HISTORIC AND DESIGN REVIEW COMMISSION

October 05, 2022

HDRC CASE NO: 2022-505
ADDRESS: 515 CLUB DR
LEGAL DESCRIPTION: NCB 7070 (R MATAMOROS SUB), BLOCK 9 LOT 25
ZONING: RM-4, H
CITY COUNCIL DIST.: 7
DISTRICT: Monticello Park Historic District
APPLICANT: Gilbert Garza/Garza Design-Build LLC
OWNER: Celeste Leija
TYPE OF WORK: New construction of a 1-story, single-family residence
APPLICATION RECEIVED: September 16, 2022
60-DAY REVIEW: Not applicable due to City Council Emergency Orders
CASE MANAGER: Rachel Rettaliata

The applicant is requesting conceptual approval to construct an approximately 2,400-square-foot 1-story, single-family residential structure.

FRONT ELEVATION
Scale: 1/4" = 1'-0"

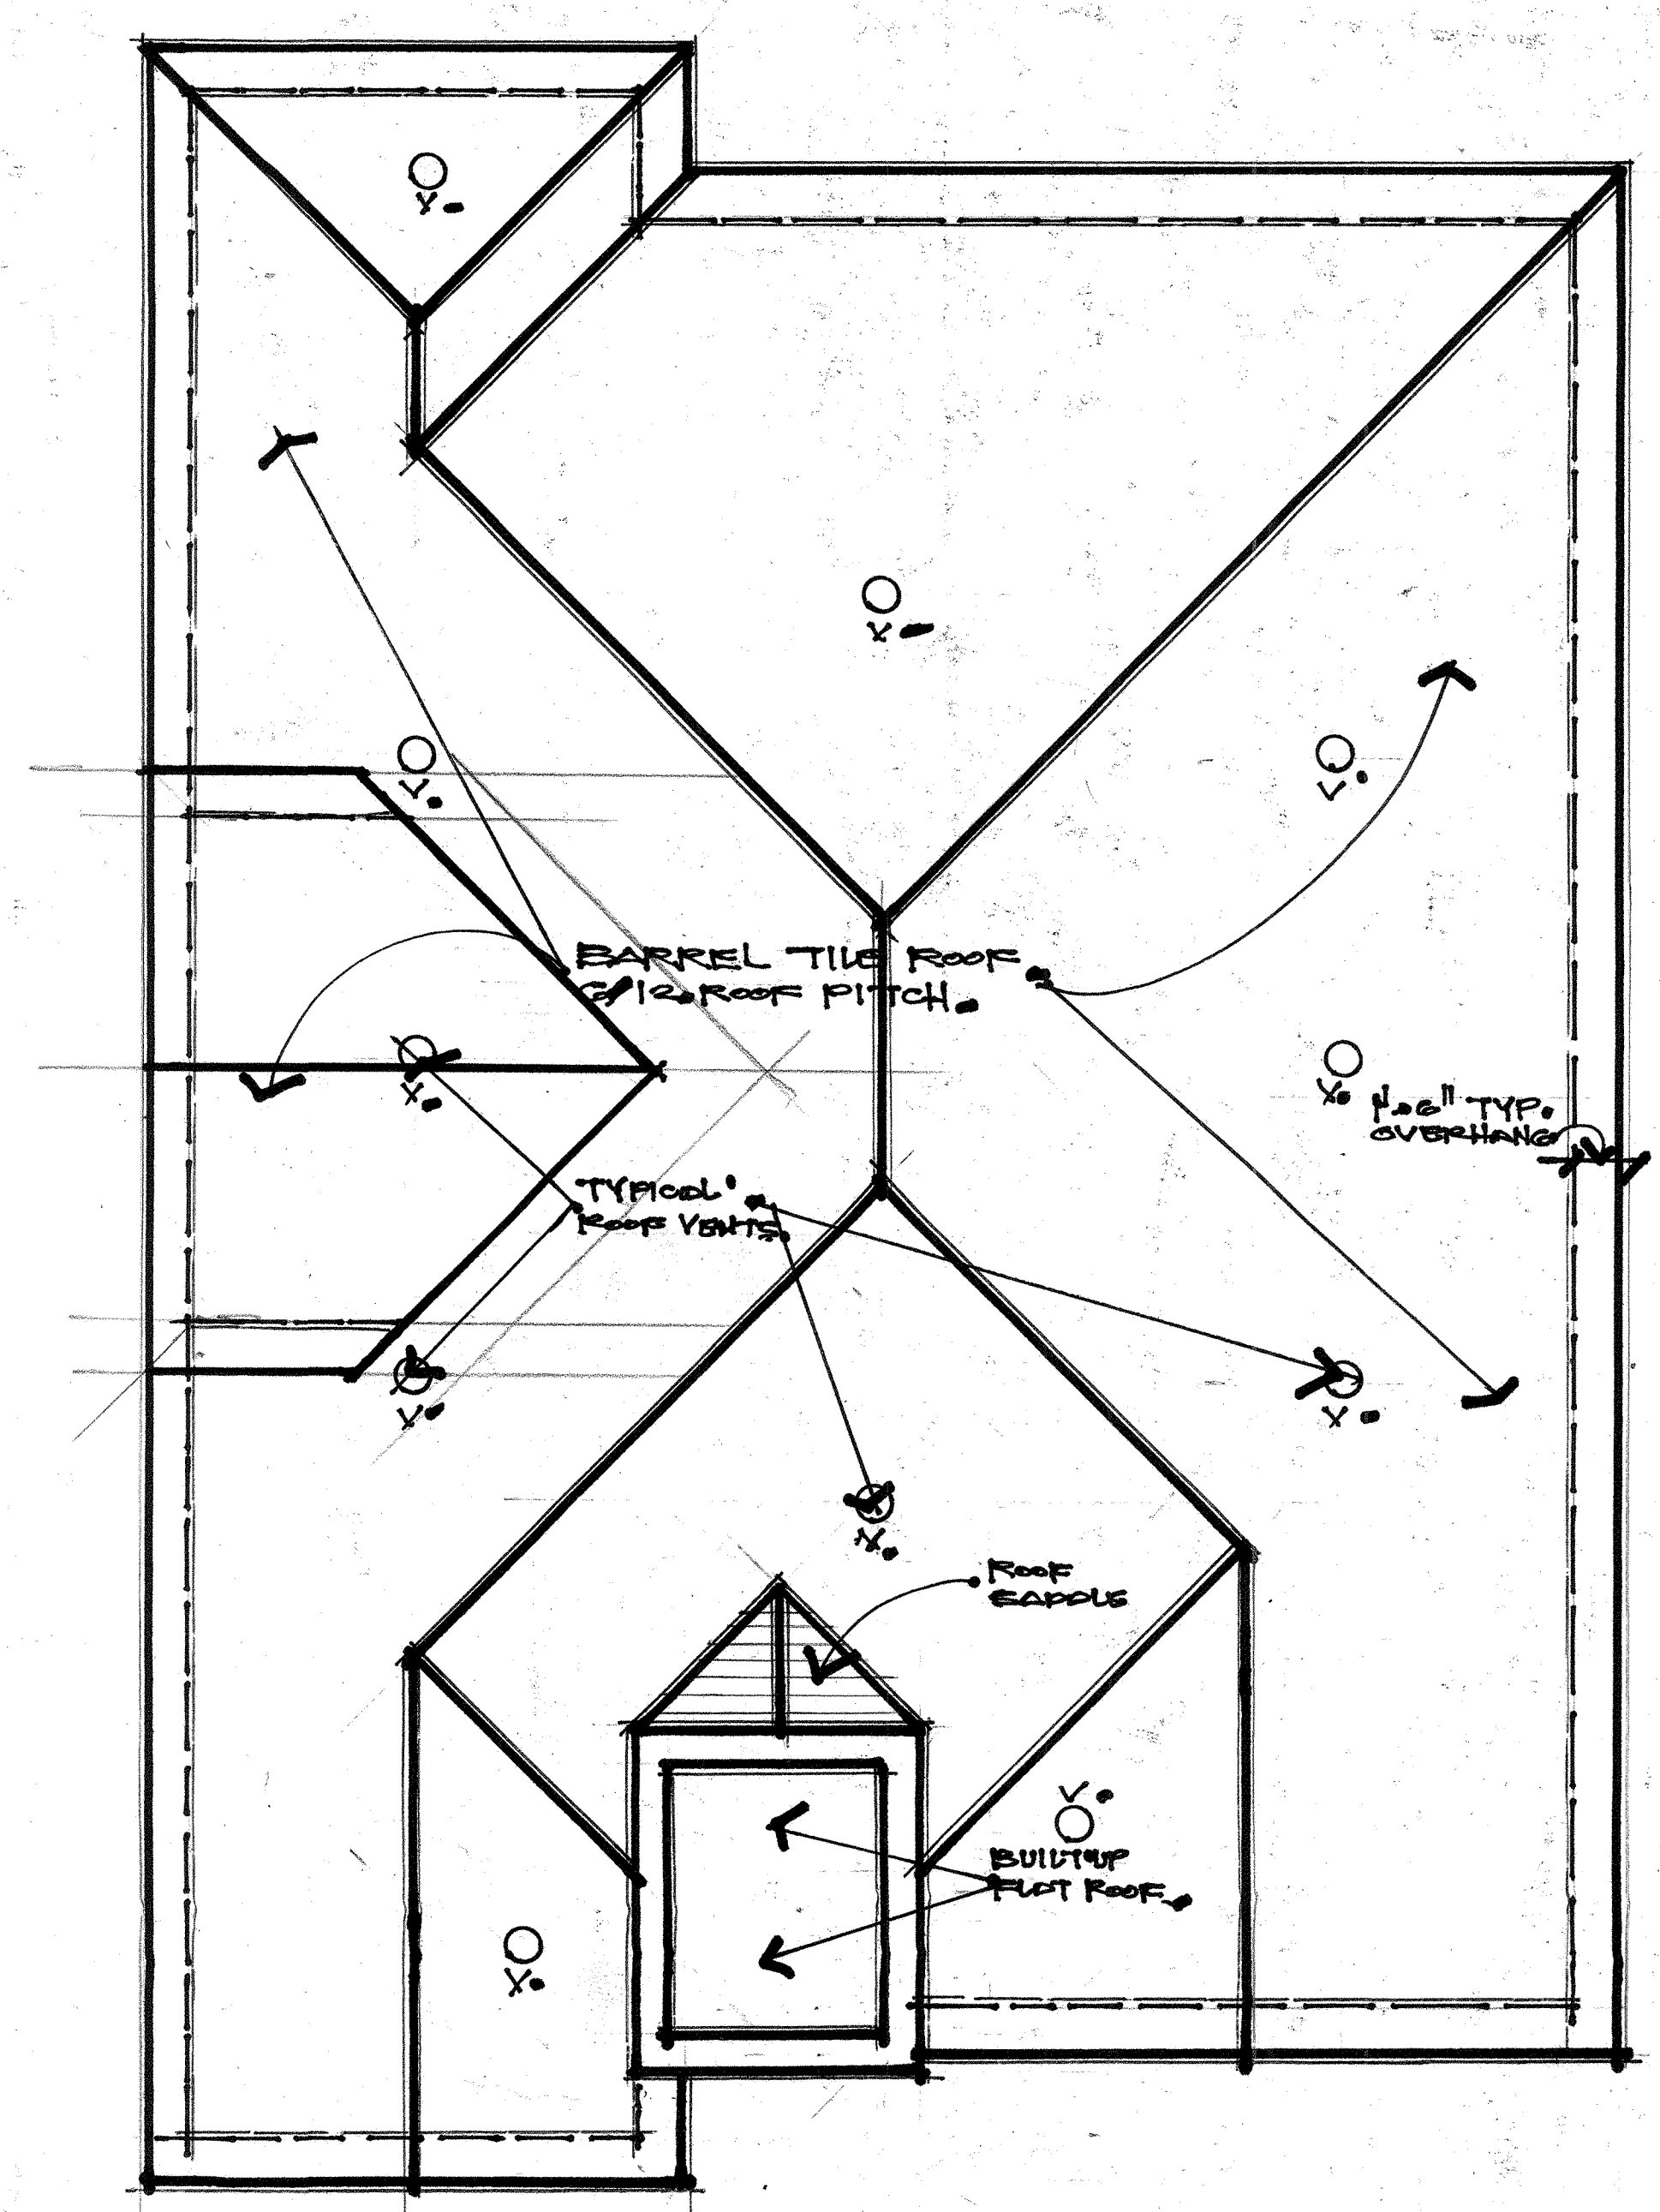
gables. According to Guideline 2.B.i for New Construction, new construction should feature roof forms that are consistent with those predominantly found on the block. The adjacent structures on Club Drive feature front gable, cross gable, low-sloped front gable, and hip roof forms. Staff finds that the applicant should simplify the proposed front roof forms to be more consistent with the roof forms found in the vicinity.

- l. GARAGE – The applicant has proposed to construct an attached front-facing, two-bay carport on the east side of the front facade. Guideline 5.A.i for New Construction states that new garages and outbuildings should be designed to be visually subordinate to the principal historic structure in terms of their height, massing, and form. The proposed garage is setback approximately 2' – 8" from the front-most portion of the front façade. According to Guideline 5.B.i for New Construction, the predominant garage orientation found along the block should be matched. Do not introduce front-loaded garages or garages attached to the primary structure on blocks where rear or alley-loaded garages were historically used. Although three out of the five single-family residential structures on this immediate block of Club Drive feature front-facing garages, residential structures in the Monticello Park Historic District traditionally feature a primary structure along the street and a rear detached accessory structure accessed either from a service alley or by a driveway from the street. Staff finds that a detached garage should be utilized in lieu of the proposed attached front-facing garage.

- iii. That the applicant simplifies the proposed front roof forms to be more consistent with the roof forms found in the vicinity and submits updated elevation drawings to staff for review prior to returning to the HDRC based on finding f.

- vii. That the applicant updates the proposed fenestration to feature traditional proportions and window configurations commonly found in the district and submits updated elevation drawings to staff for review prior to returning to the HDRC based on finding j.

- viii. That the applicant simplifies the architectural details that relate to the period of construction on the block to be more in keeping with the Guidelines as opposed to the proposed Spanish Eclectic detailing as noted in finding k.

- ix. That a detached garage is utilized in lieu of the proposed front-facing attached garage based on finding l. If the HDRC finds the proposed attached garage appropriate, staff recommends that the garage is recessed substantially from the front façade.
